Environmental Minor Project Refinement Form

Project Name: West of Devers Upgrade Project **Request Prepared By:** Sylvia Granados

Date Approval Required: 12/6/2019 **Variance Request No.:** 32

FIGURE 1
Page 11 of 13

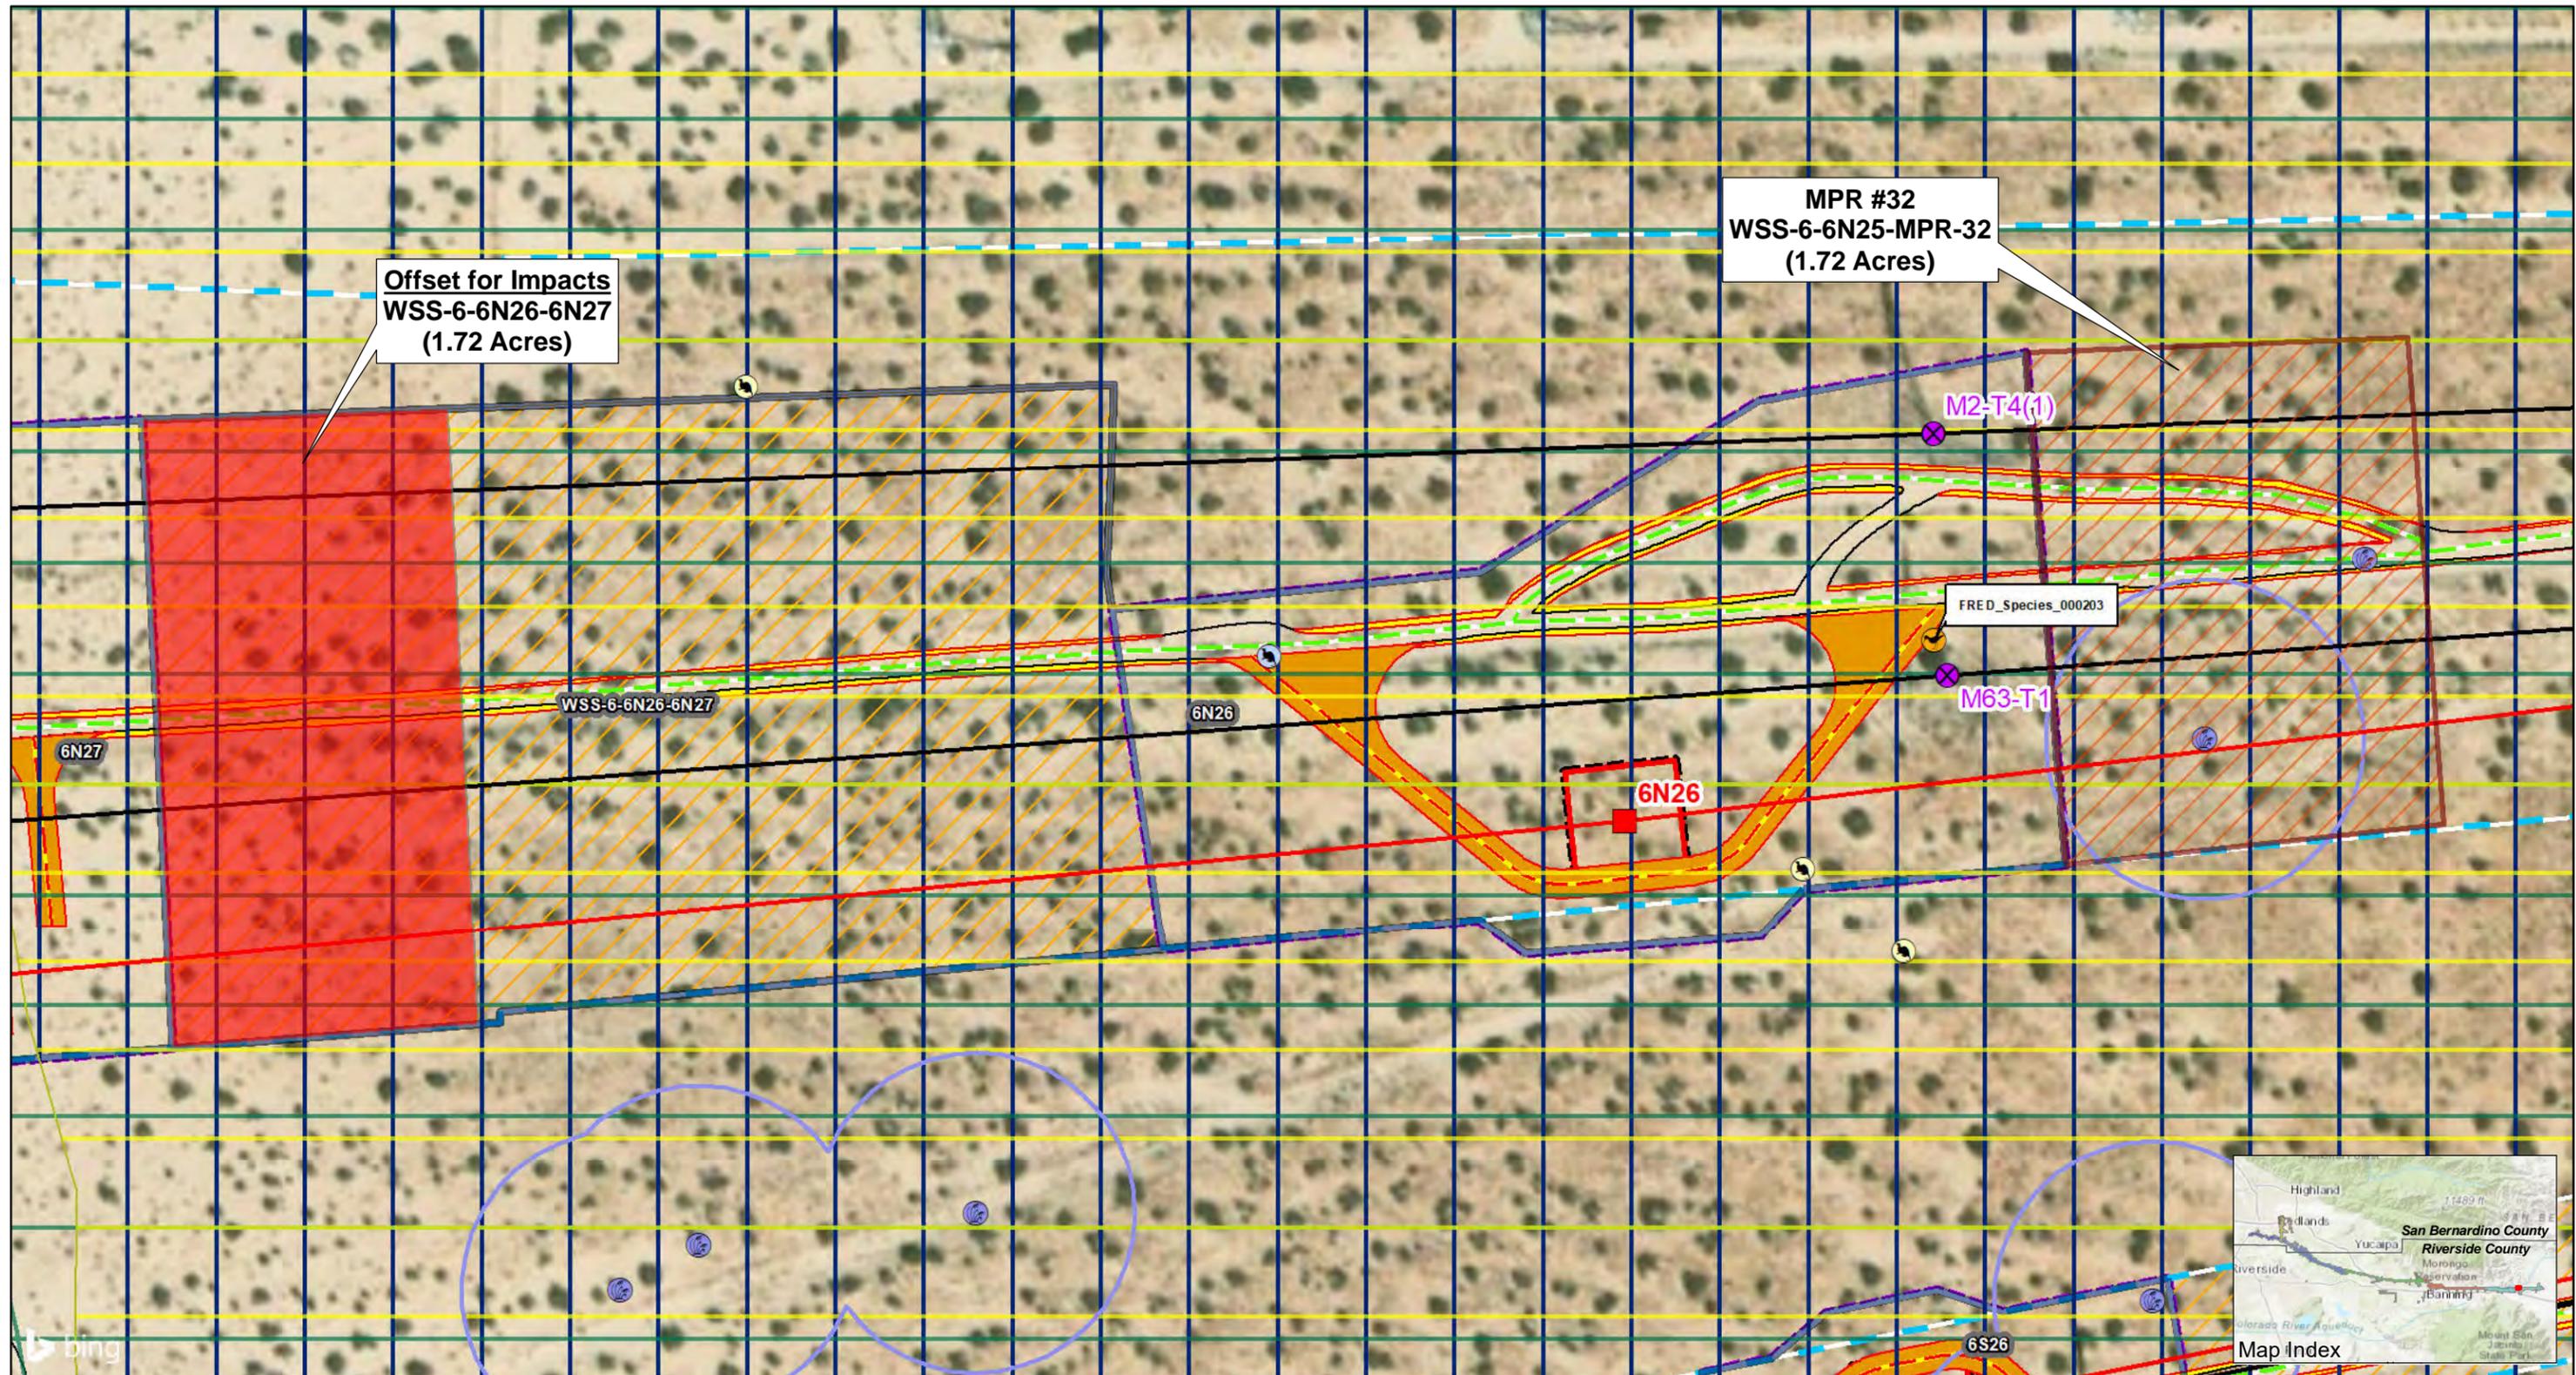
WA-4-4X04-3-SE-MPR-32: Expansion of Supersite 4X04-3-SE

Supersite 4X04-3-SE requires expansion to the east to create a turnaround area for vehicles and equipment traveling along the access road, as shown on Figure 1, Page 11. The new work area will require minimal site preparation for use.

The total temporary disturbance area associated with the new work areas consists of approximately 0.03 acre of developed/disturbed land (.01 acre) and chaparral (.02 acre). The land is privately owned and located within the SCE transmission line right-of-way.

FIGURE 1
Page 13 of 13

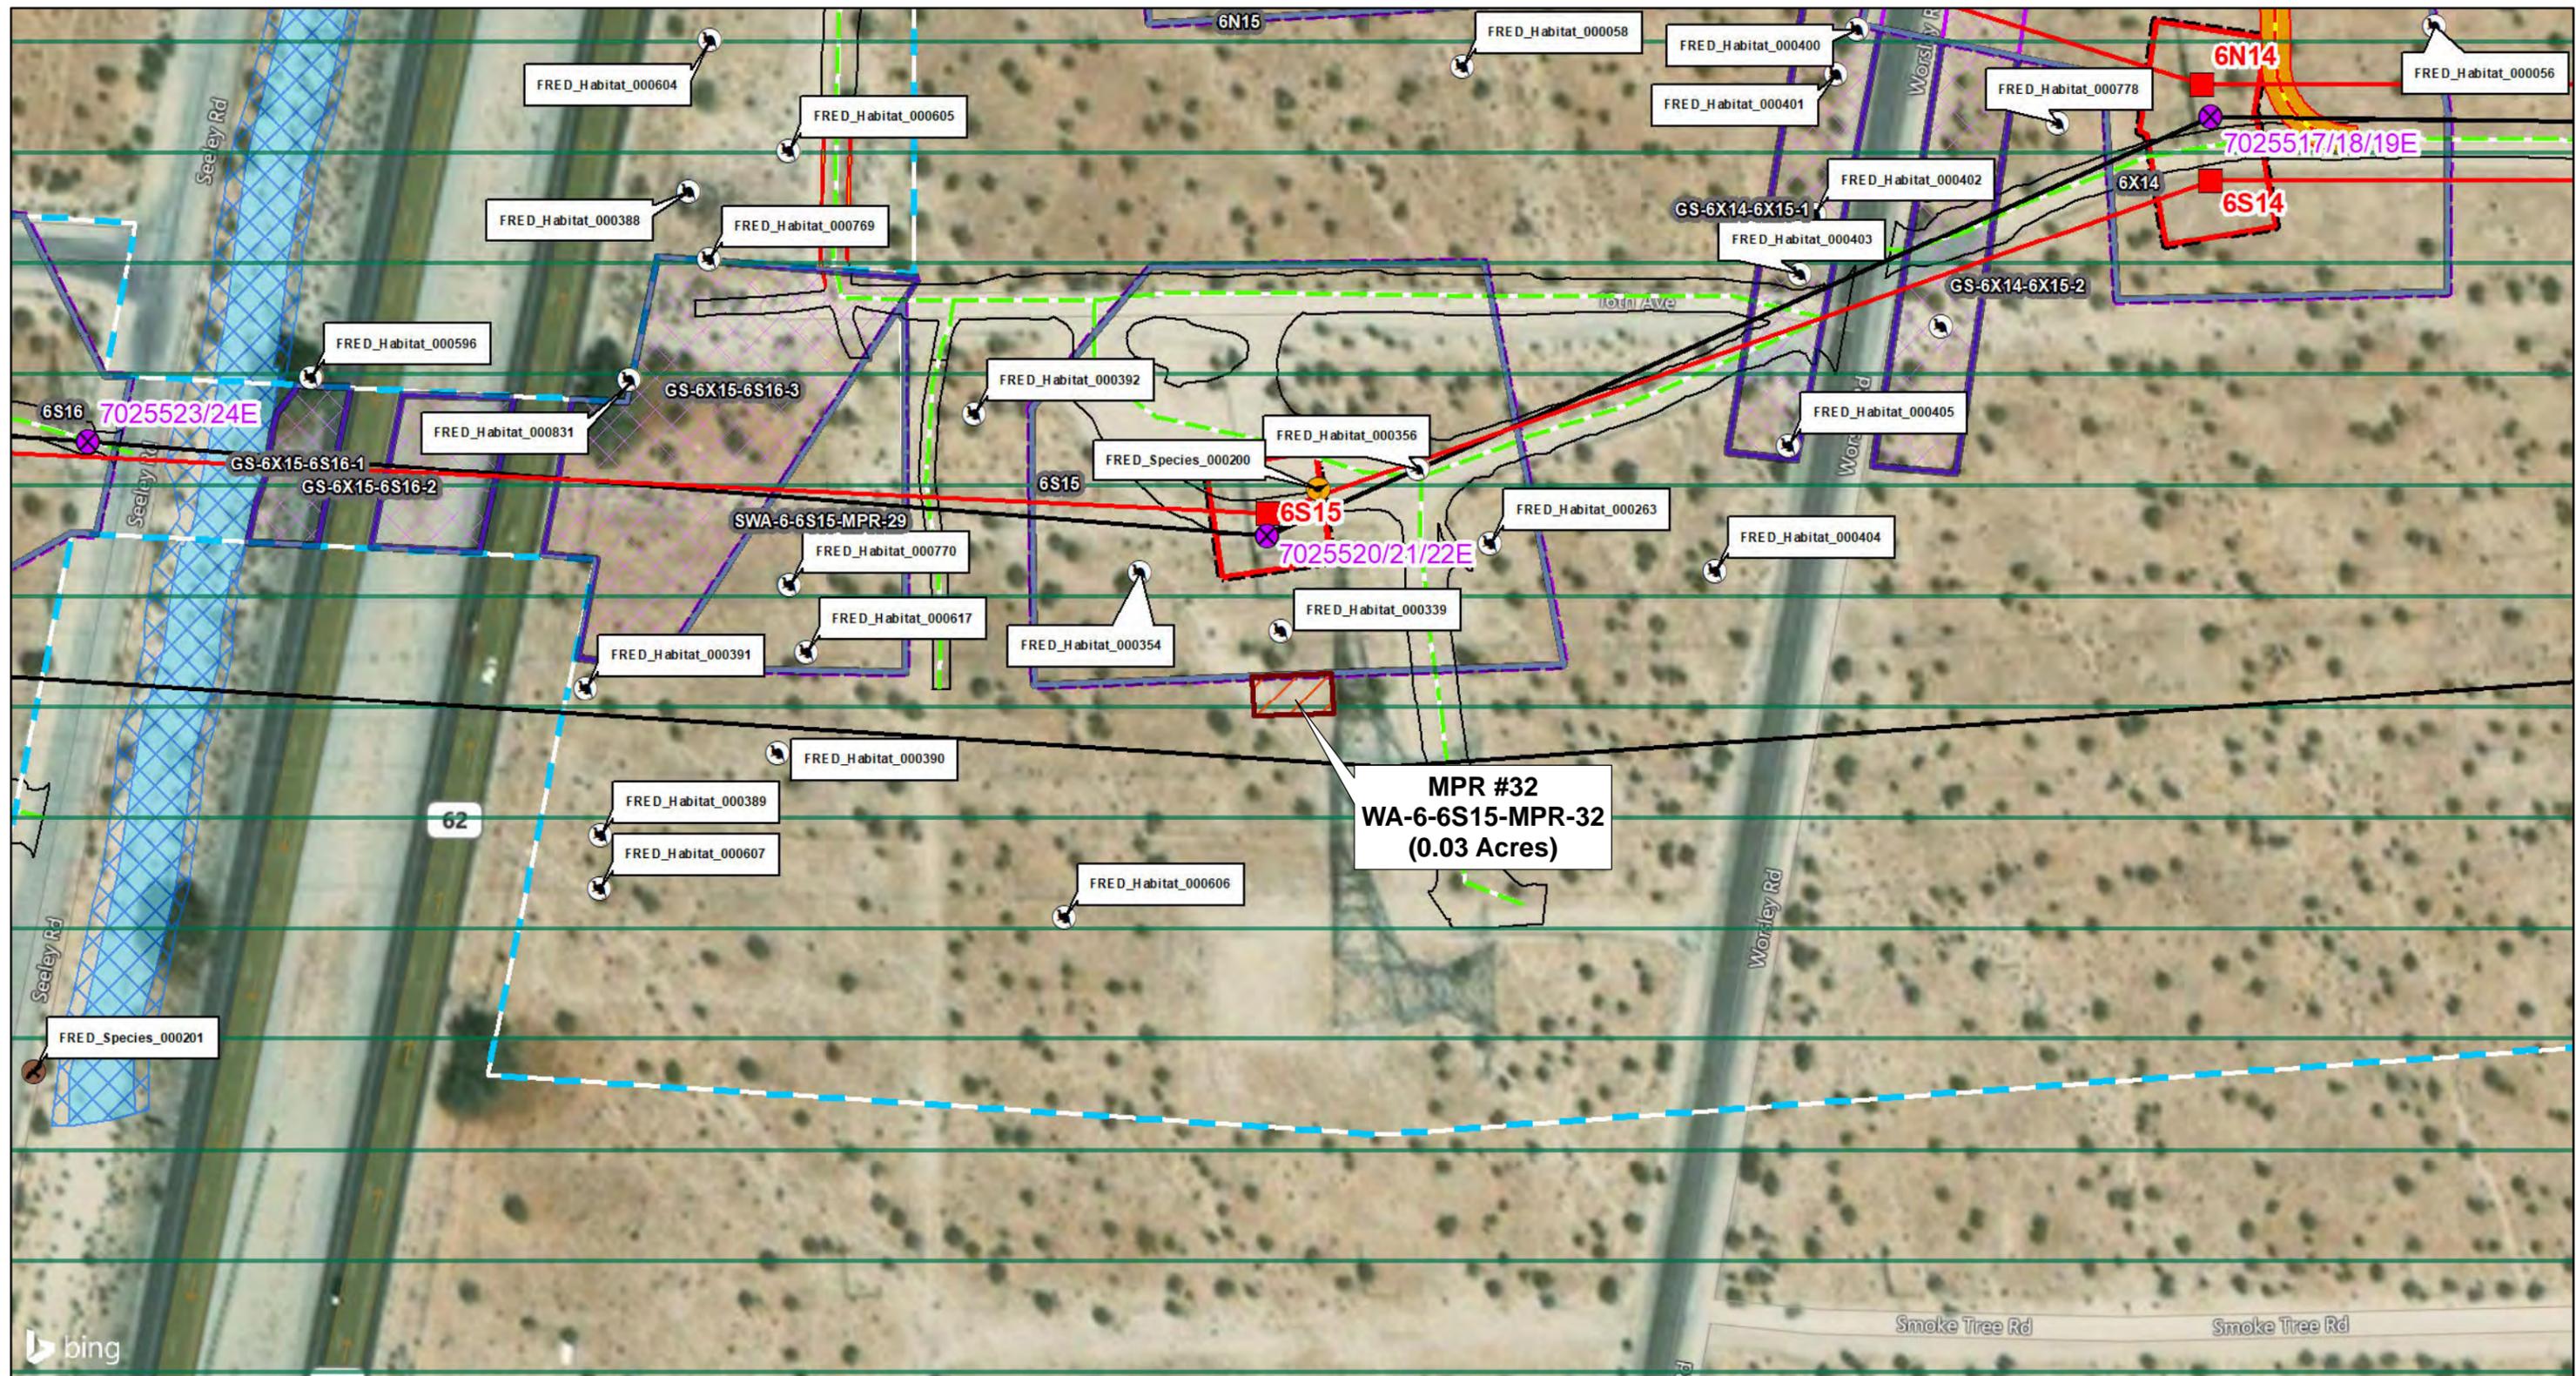
WA-6-6S15-MPR-32: Expansion of Supersite 6S15

Supersite 6S15 requires expansion to the south to provide adequate work space for material and equipment staging during removal of an existing guy anchor located outside of the currently approved work area, as shown on Figure 1, Page 13. The new work area will require minimal ground disturbance in preparation for use.

The total temporary disturbance area associated with the new work area consists of approximately 0.03-acre of desert scrub. The land is privately owned and located within the SCE transmission line right-of-way.
